# CITY OF ALBUQUERQUE

RE: **Shawn McWethy Park**  
**Grading and Drainage Plan**  
**Grading Permit / Paving Permit**  
**Engineer's Stamp Date 10/19/2015 (File: J09D023A)**

Based upon the information provided in your submittal received 9-15-2015, the above referenced Grading and Drainage Plan for Grading Permit and Paving Permit cannot be approved until the following items are addressed in a revised submittal:

**A3** CONCRETE RUNDOWN  
N.T.S.

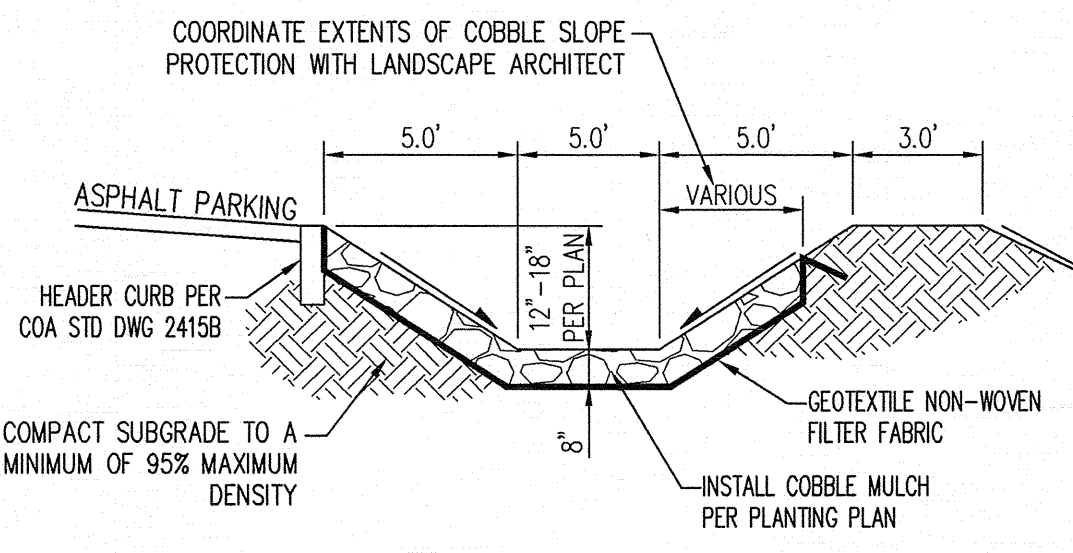
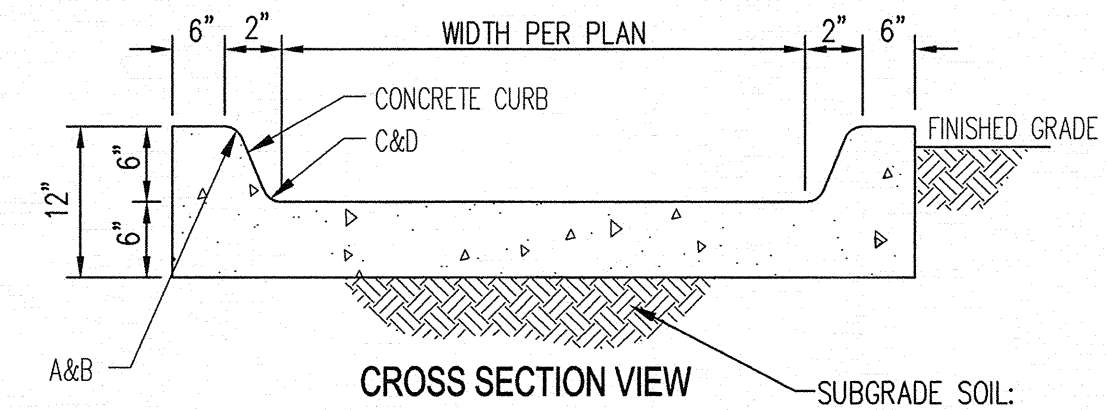
- Provide an excerpt from the approved Drainage Masterplan referenced (cover, table of contents and applicable section), which allows the peak discharge of 15.07 cfs from the site.
- Provide a capacity calculation for the swale along the north edge of the property.
- Provide a capacity calculation for the rundown from Basin 7.
- Clarify how the first flush from the parking lot enters the water quality pond.
